TUNITAS CREEK BEACH IMPROVEMENTS PROJECT

**COUNTY PROJECT NO. P30T1
PROJECT FILE NO. E4995**

ADDENDUM NO. 1

The following **Addendum No. 1** to the above referenced project, dated April 21, 2023, shall be included in the project specifications and plans.

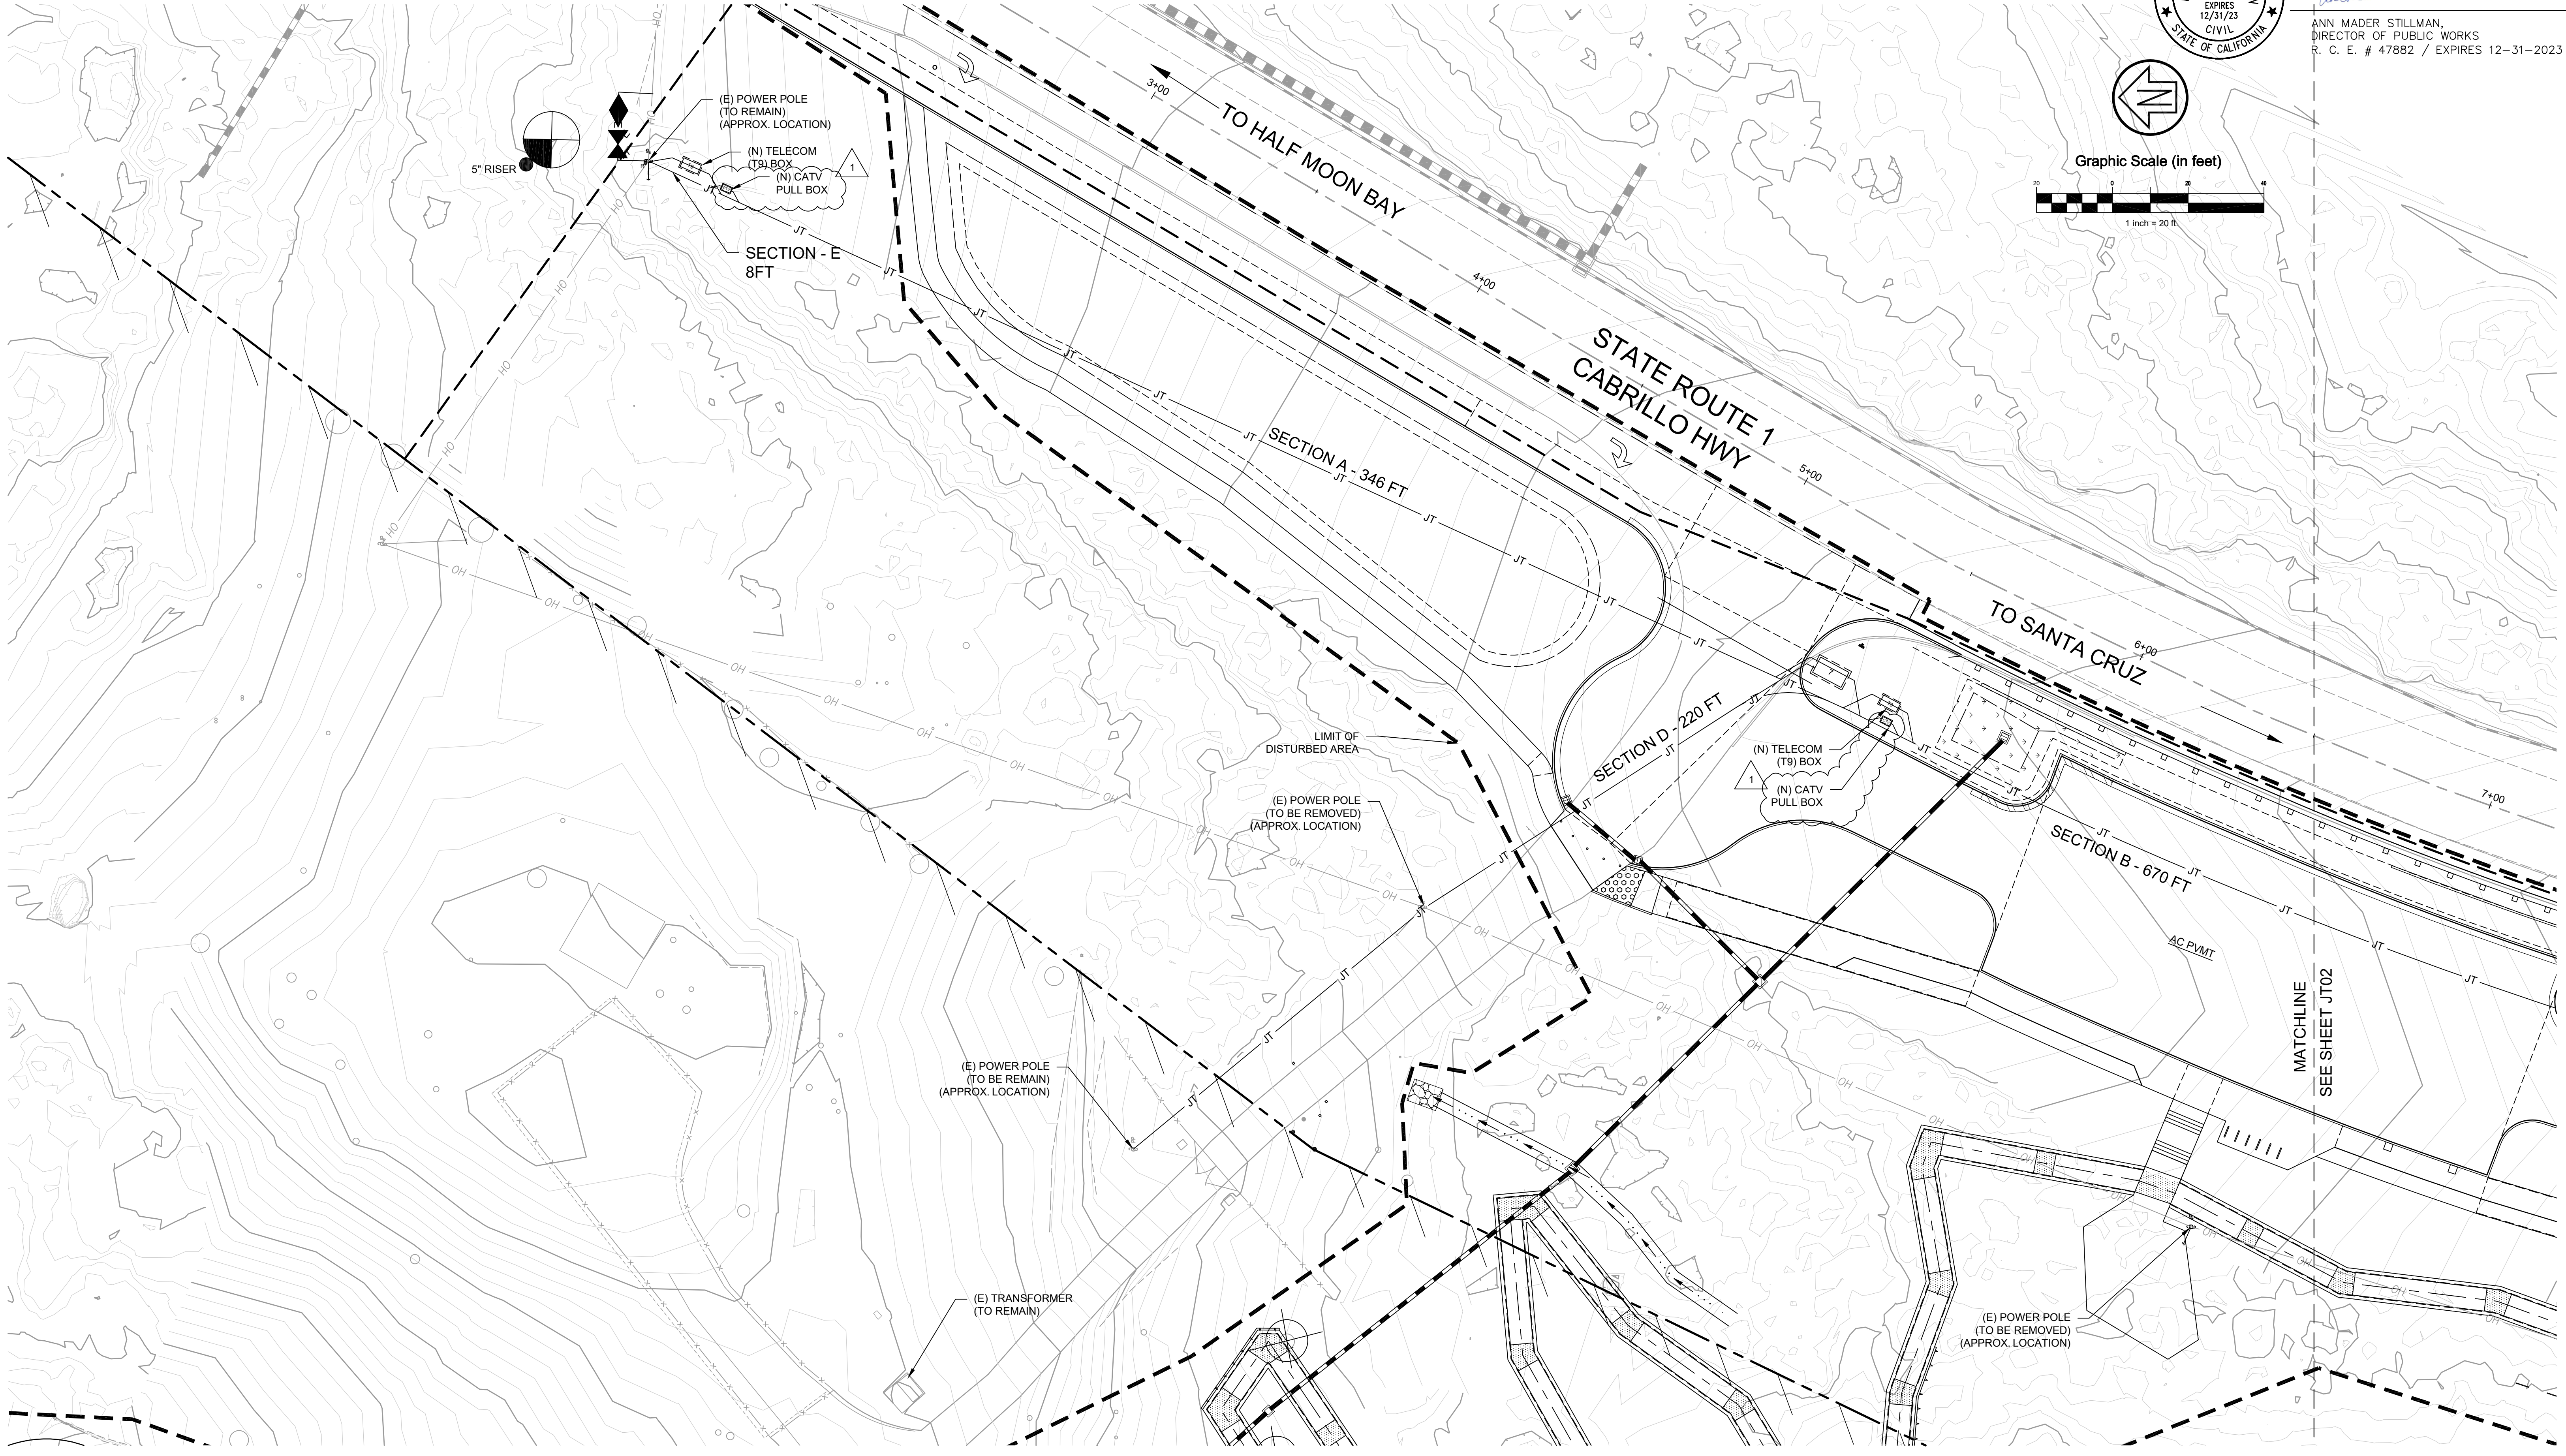
14. The Joint Trench Plan Sheets have been updated to show the locations of the cable TV pullboxes. Plan Sheets JT00, JT01, JT02, and JT03 shall be replaced in the Project Plans:

Replace Plan Sheet JT01 (Sheet 61 of 124) with Sheet JT01 (rev) (Sheet 61 of 124).

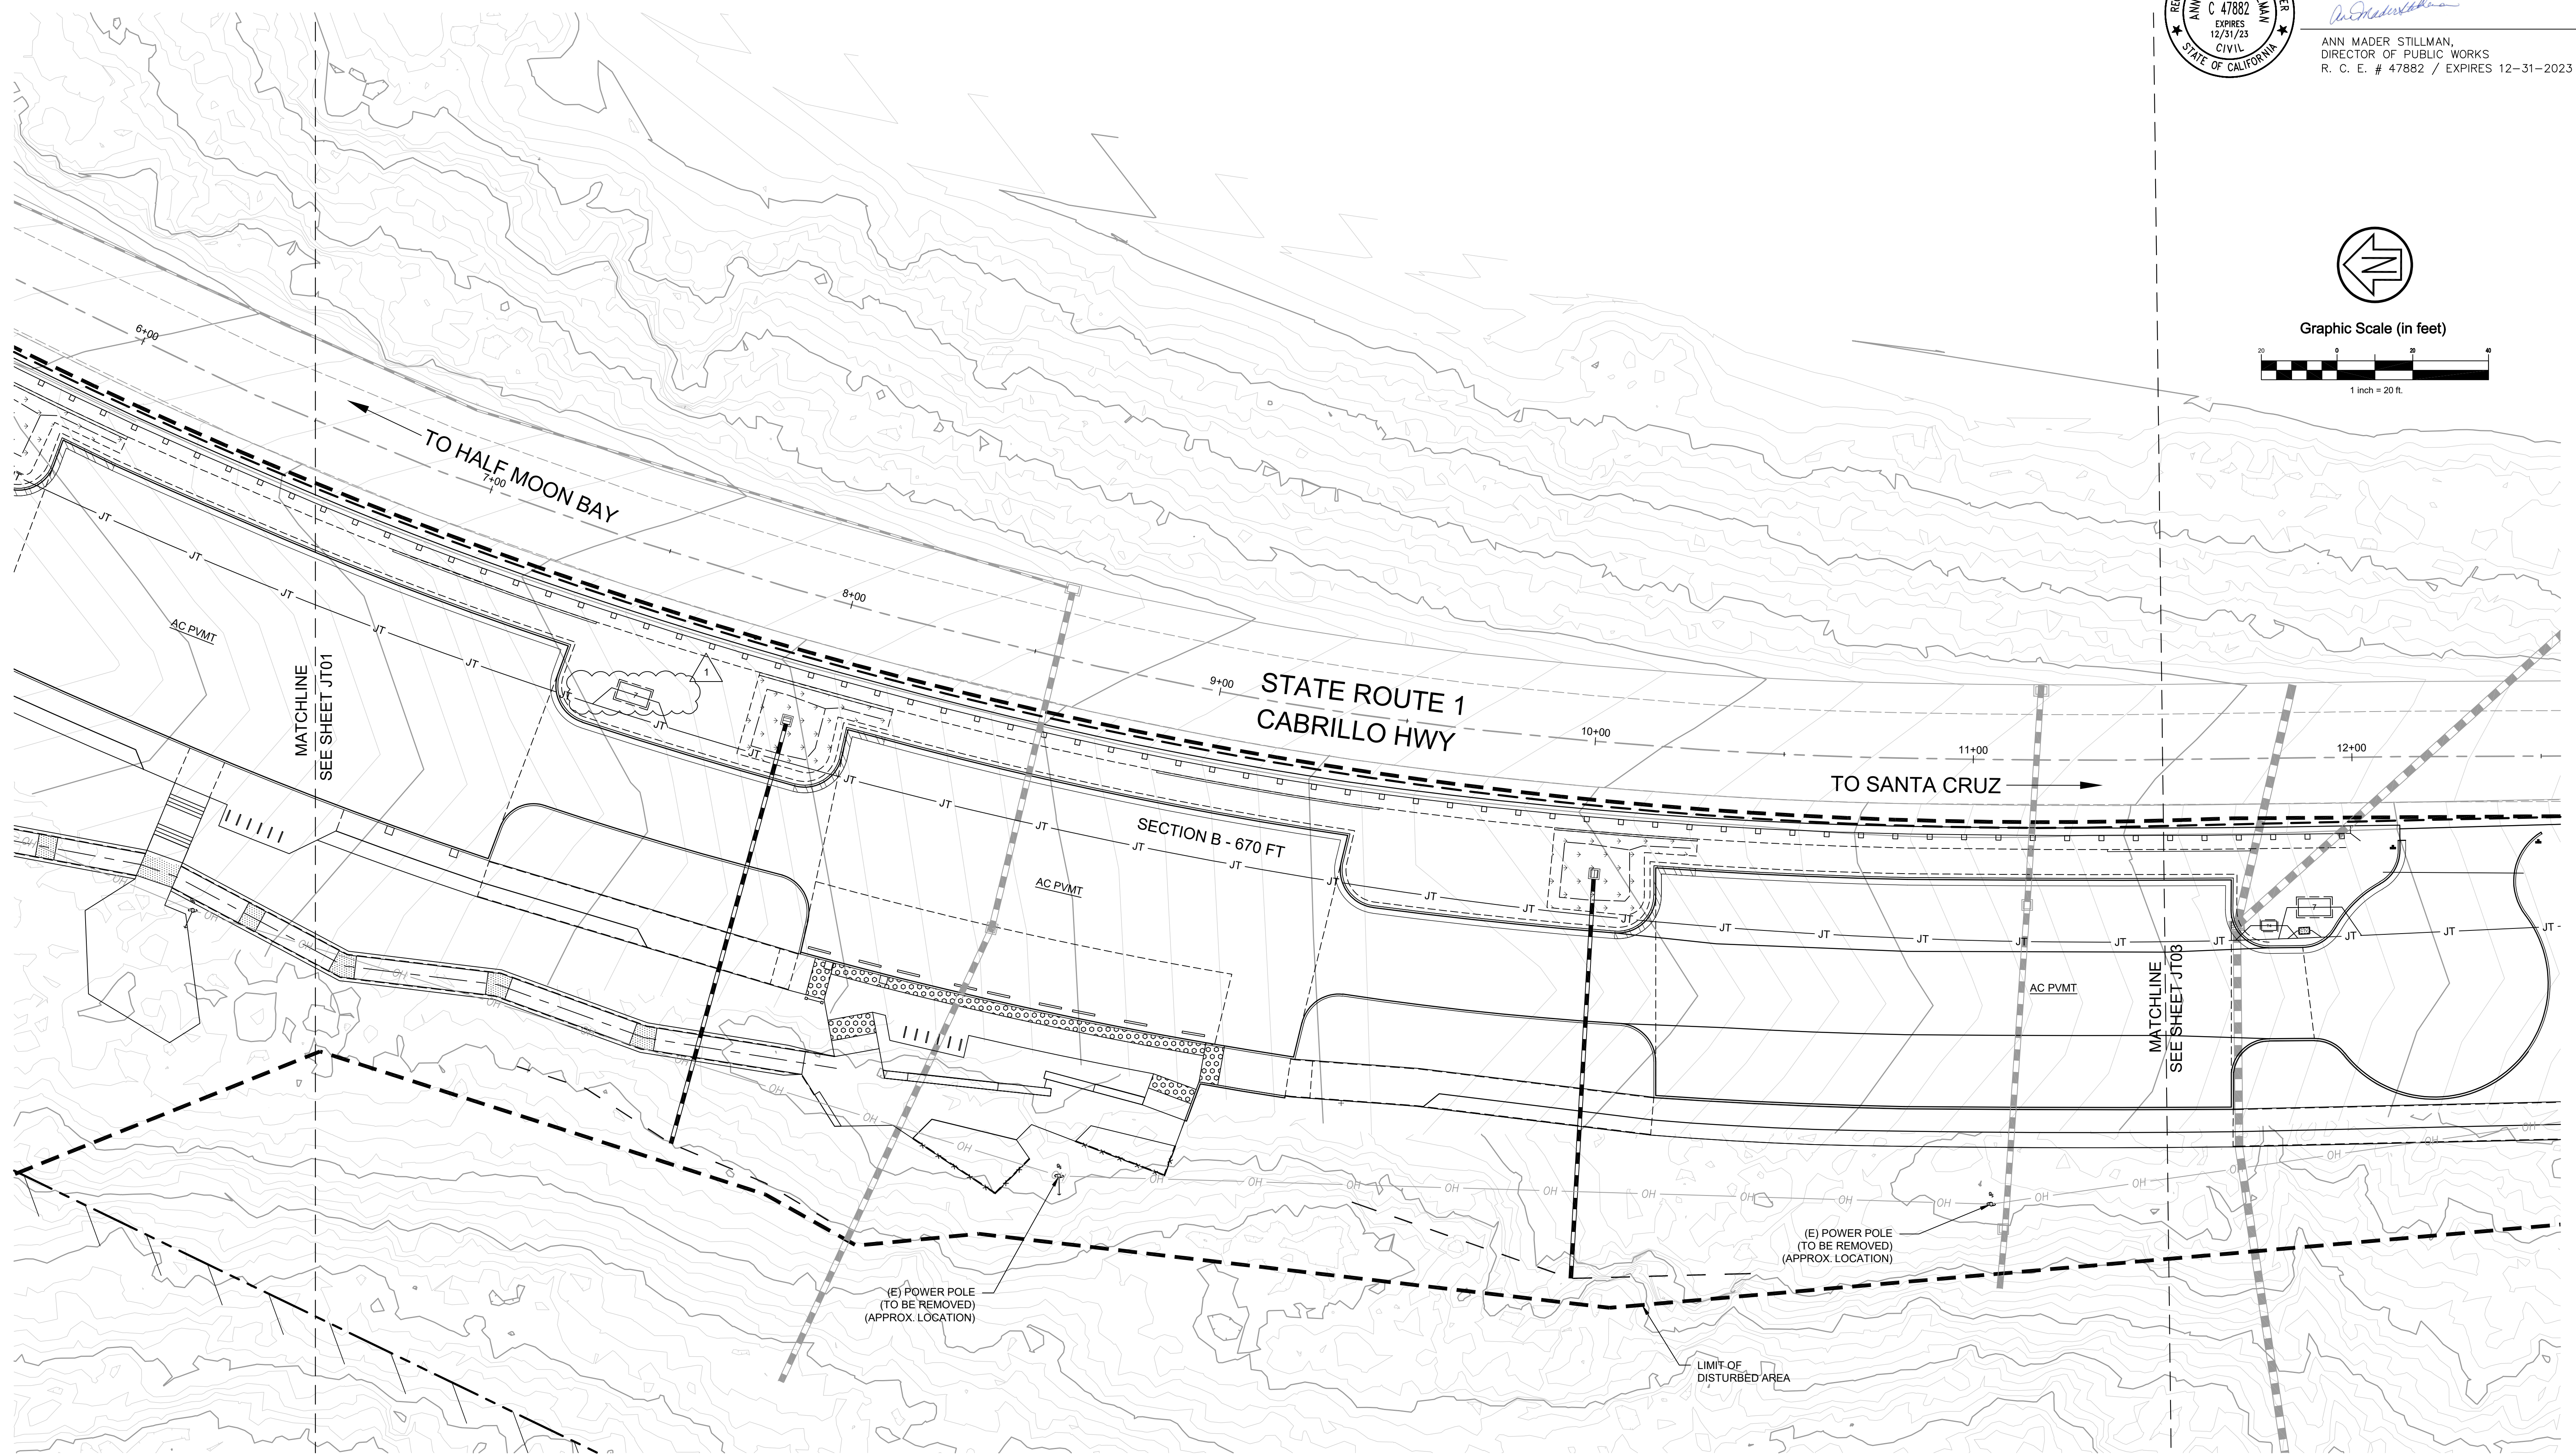
Replace Plan Sheet JT02 (Sheet 62 of 124) with Sheet JT02 (rev) (Sheet 62 of 124).

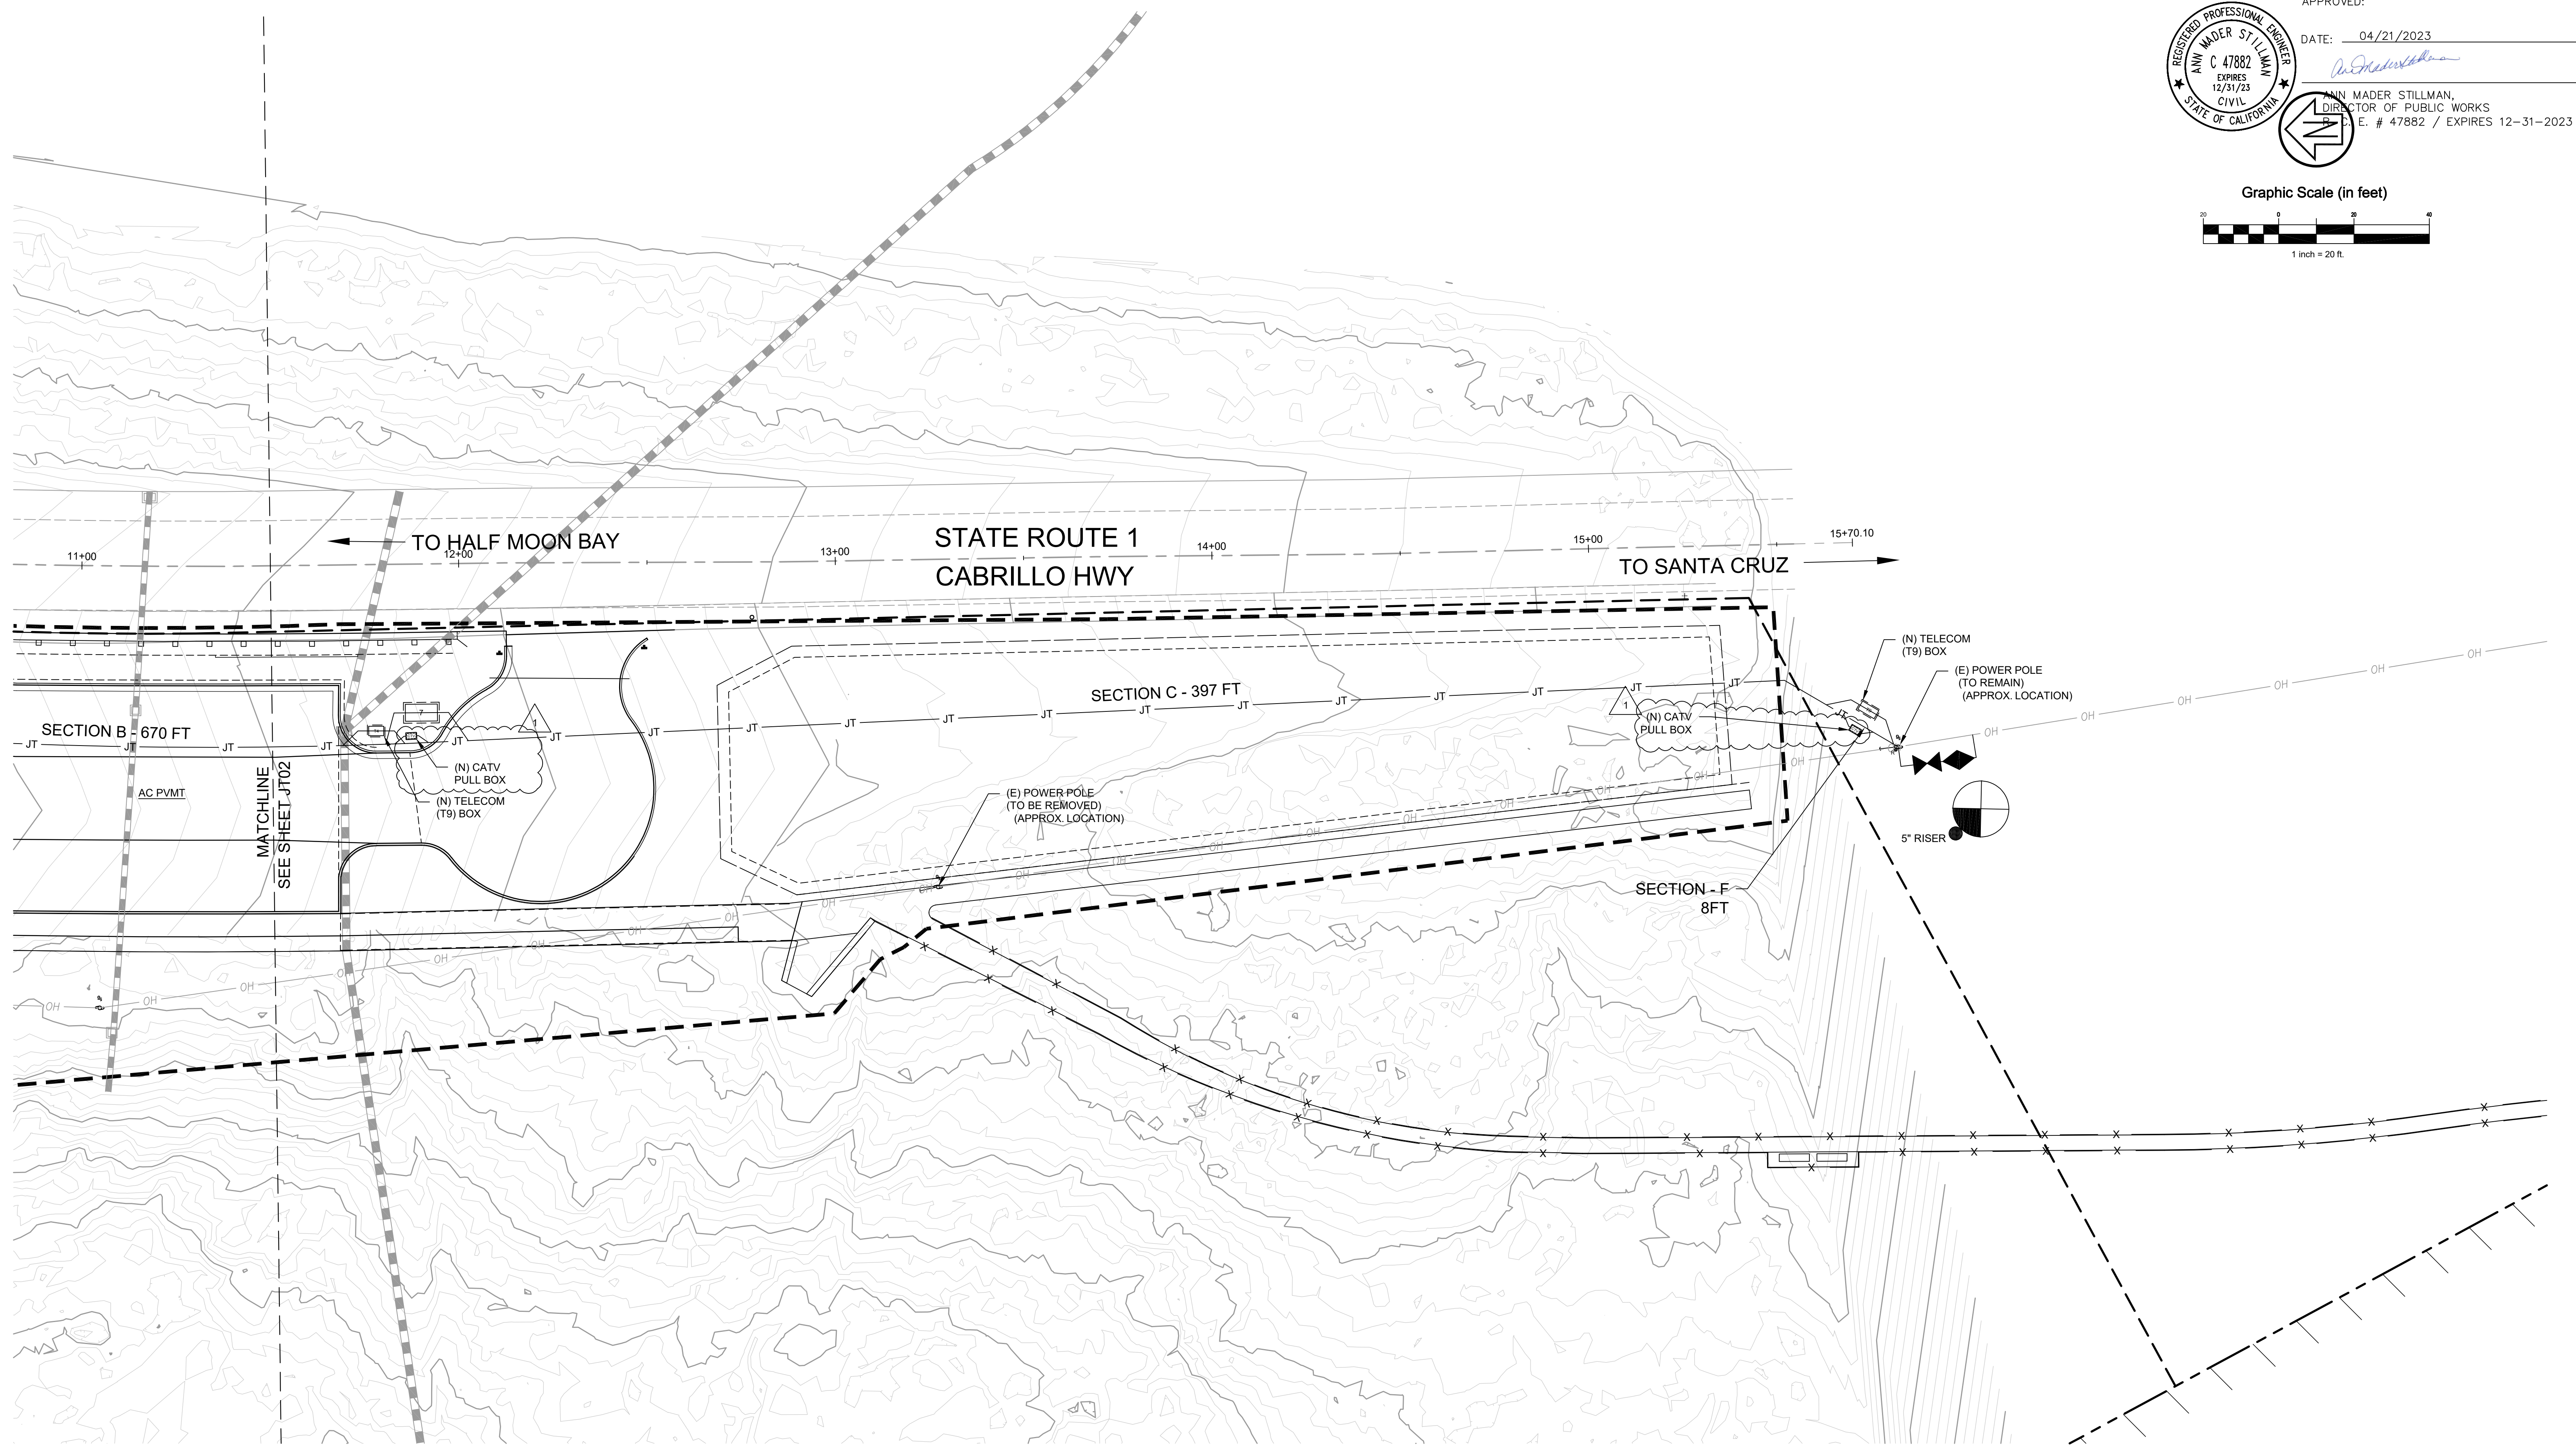
Replace Plan Sheet JT03 (Sheet 63 of 124) with Sheet JT03 (rev) (Sheet 63 of 124).
